NEW MEXICO OIL CONSERVATION DIVISION

INJECTION WELL DATA SHEET

OPERATOR: **COG Operating, LLC.**WELL NAME & NUMBER: **Lakewood SWD #4 (Re Entry of API 30-015-26270)**

Subject: COG Lakewood SWD #4

Well: Lakewood SWD #4 (formerly Howe 6L)

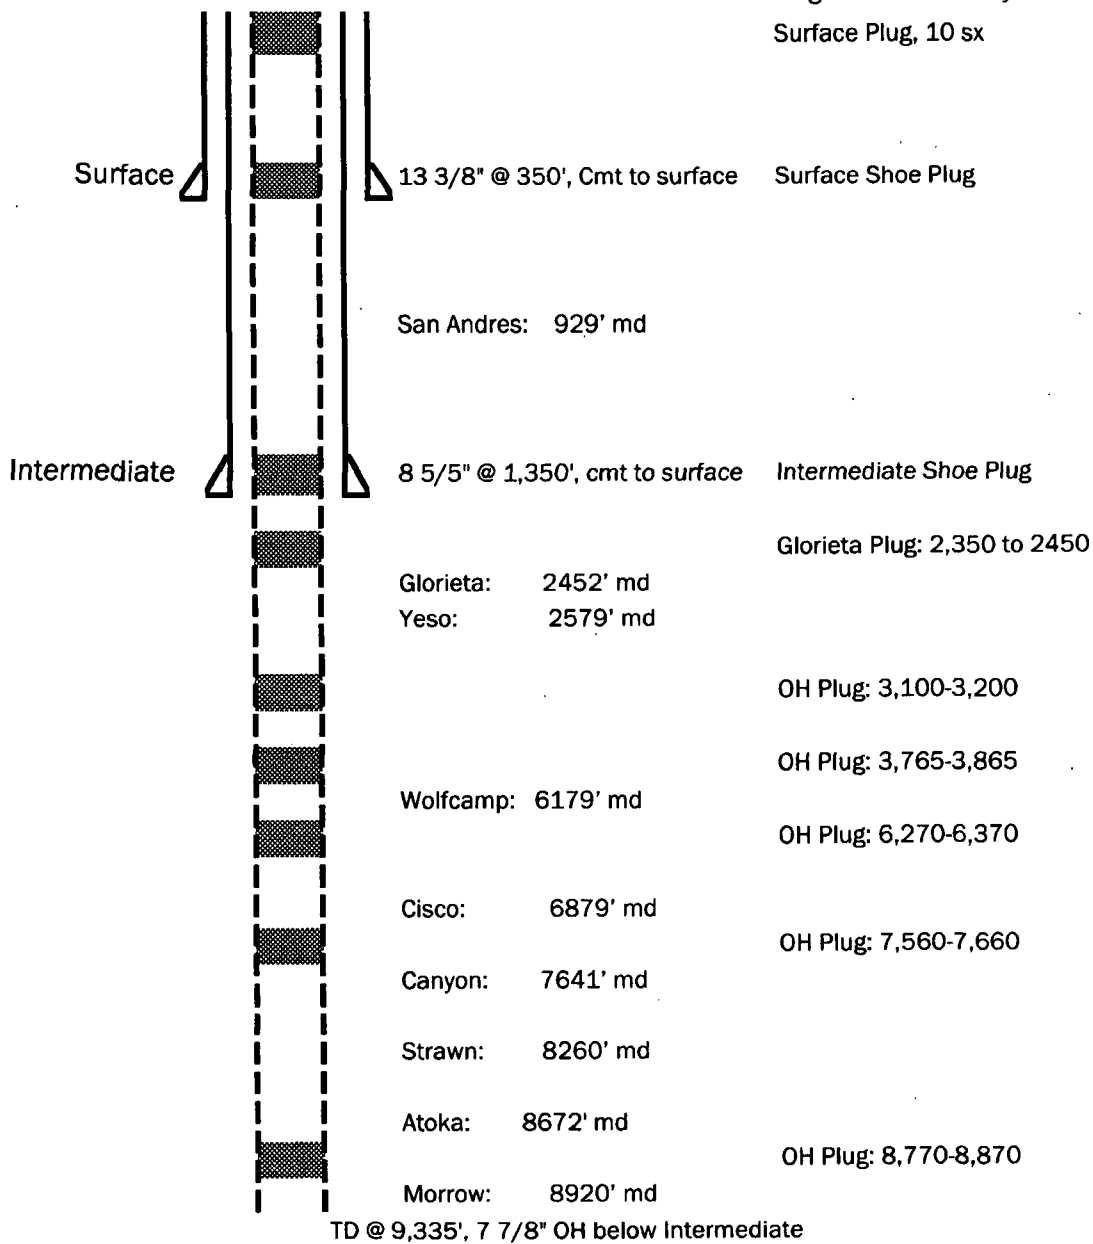
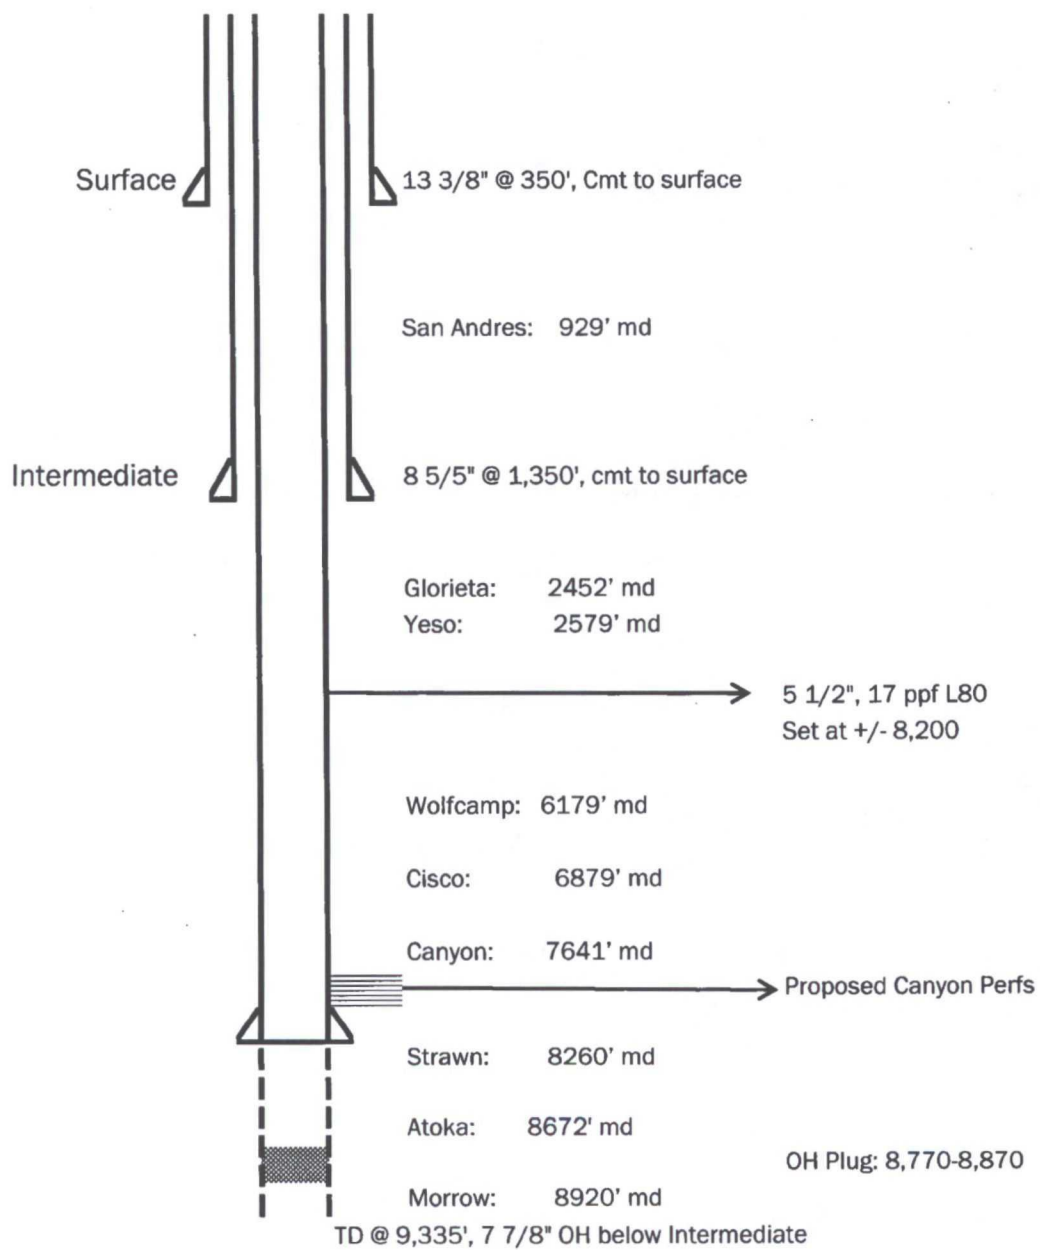
Attached are two spreadsheets that show the original perfs from our geologist as: 7,860 to 7,967 as shown on my C-108; a second one with new perfs 7,846 to 7,984. Please let me know how you want this handled. Thanks

PERF TOP DEPTH	PERF BOTTOM DEPTH	SPF=4	
7964	7967	3	12
7936	7950	14	56
7914	7922	8	32
7898	7906	8	32
7882	7894	12	48
7867	7878	11	44
7846	7860	14	56
	121	70	100

Haha,
OK I will do the amendment.
